Access Compliance Report Public Rights-of-Way (Curb Ramps)

Main Street: AGAPANTHUS_ST		Cross Street: AGAPANTHUS_ST		Location:	N
ADA ID: RPRK211111122923	Ramp Type: Type 4 - Parallel	Initial Pass/Fail: Pass	Overall Compliance: No	Severity Score:	20
Codes/Mitigation Info/Possible Solution			Field Measurements/Component Compliance

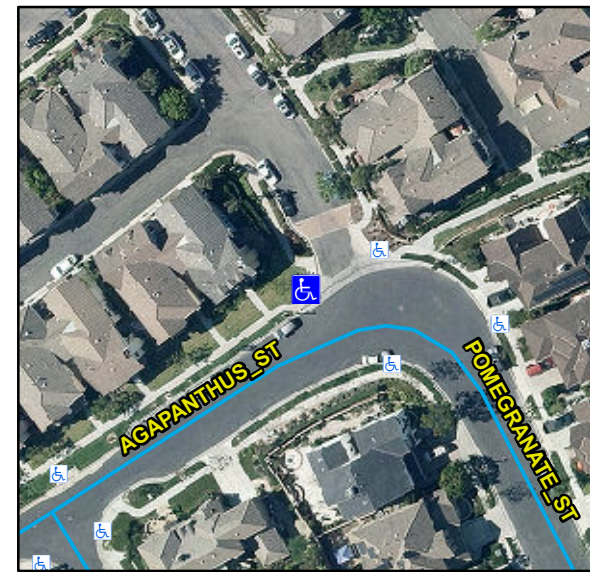
R204.3, R304.2.1, R304.2.2-Perp, R304.3.2-Para, R304.5.3, R305, STD 1115

Remove & Replace Curb Ramp With Two New Directional Ramps or Equivalent.
